Class II Change Declaration Letter

Product Name: Wireless N Home Network Camera

Model No. : DCS-930, DCS-930L

DCS-930-old-PCB

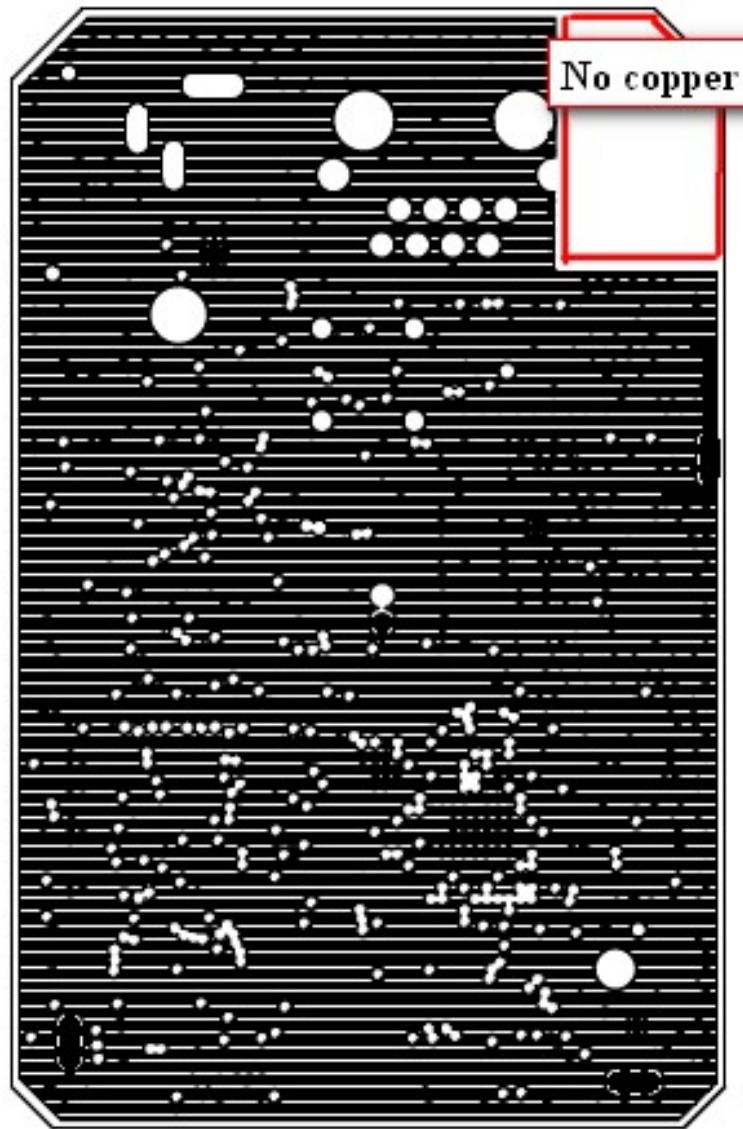
Reason to Change	Difference
1. Improve the device's transmit and receive performance 2. Cost down	1. Change chip antenna to PCB antenna 2. Add copper in the 2 nd PCB layer (under chip antenna area)
Change chip antenna to PCB antenna	Remove R78, P3
